**Subject: Beaver Valley Power Station, Unit No. 1  
BV-1 Docket No. 50-334, License No. DPR-66  
Emergency Response Data System (ERDS)**

BEAVER VALLEY POWER STATION ERDS DATA POINT LIBRARY  
BV1 ERDS INPUT

Figure 12-7  
Location of Containment Temperature  
Sensors, Seal Bulbs and Moisture Sensors

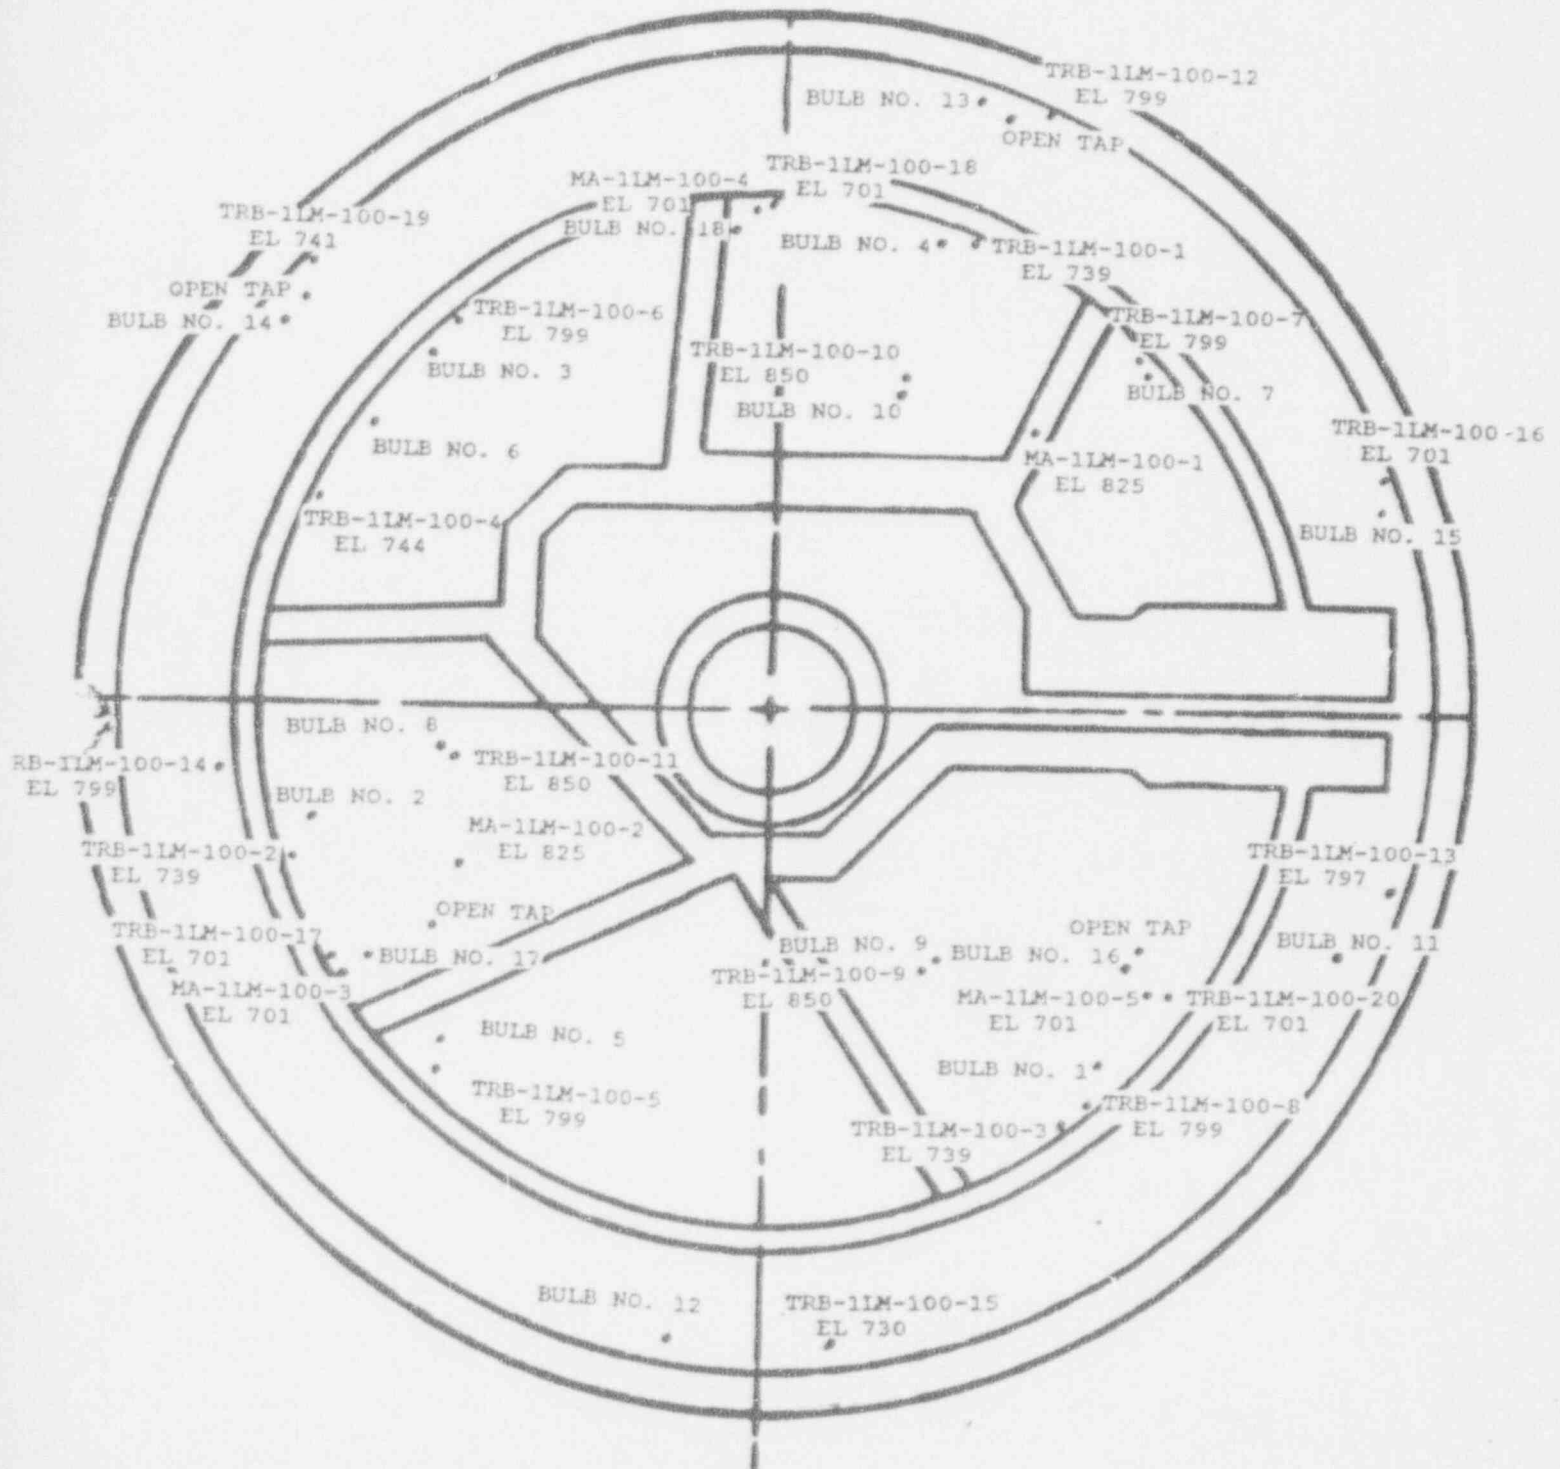
Date:	03/12/93
Reactor Unit:	BV1
Data Feeder:	PVC
NRC ERDS Parameter:	CTMNT TEMP
Point ID:	U2080
Plant Spec Point Desc.:	AVG CNMT TEMP. - TECHSPEC TRB'S
Generic/Cond Desc.:	CONTAINMENT TEMPERATURE
Analog/Digital:	A
Engr Units/Dig States:	DEGF
Engr Units Conversion:	N/A
Minimum Instr Range:	0
Maximum Instr Range:	300
Zero Point Reference:	N/A
Reference Point Notes:	N/A
PROC or SENS:	P
Number Of Sensors:	5
How Processed:	AVERAGE
Sensor Locations:	SEE UNIQUE SYSTEM DESCRIPTION FIELD
Alarm/Trip Set Points:	HI ALM @ 103 DEGF/LO ALM @ 32 DEGF
NI Detector Power Supply Cut-off Power Level:	N/A
NI Detector Power Supply Turn-on Power Level:	N/A
Instrument Failure Mode:	HIGH
Temperature Compensation For DP Transmitters:	N
Level Reference Leg:	N/A
Unique System Desc.:	U2080 IS THE AVERAGE OF ALL FIVE TEMPERATURE INPUTS. T-LM100-4 SENSES TEMPERATURE AT 744' IN THE PRESSURIZER CUBICLE; T-LM100-7 SENSES TEMPERATURE AT 799' ON THE OPERATING FLOOR WE OF THE CRANE WALL; T-LM100-10 SENSES TEMPERATURE AT 850' IN THE NNE CNMT DOME; T-LM100-15 SENSES TEMPERATURE AT 730' IN THE SSE ANNULUS; T-LM-100-16 SENSES TEMPERATURE AT 701' 6" IN THE ENE ANNULUS. (SEE ATTACHED DWG.)
